Formal Interpretations/ Interprétation formelle

This section lists questions that individuals have submitted about a particular standard. Each question has been reviewed and answered by the appropriate committee. If you would like to submit a question about a particular standard, please see the end notes in the preface of that standard.

Posted December 22, 2023

Diagram 1

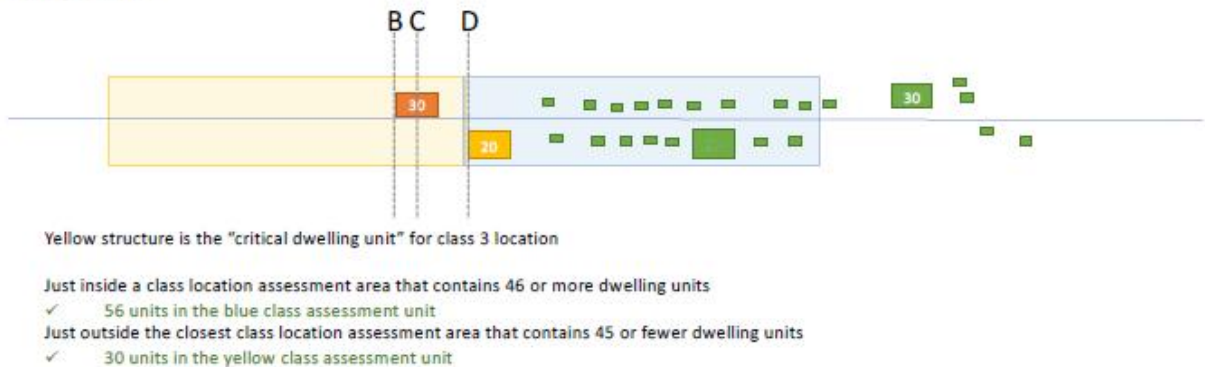
Question 2: From the diagrams provided, is the yellow 20 unit building the dwelling unit that sets the end boundary for the class 3 location as per Clause 4.3.4.5?

Answer 2: Yes
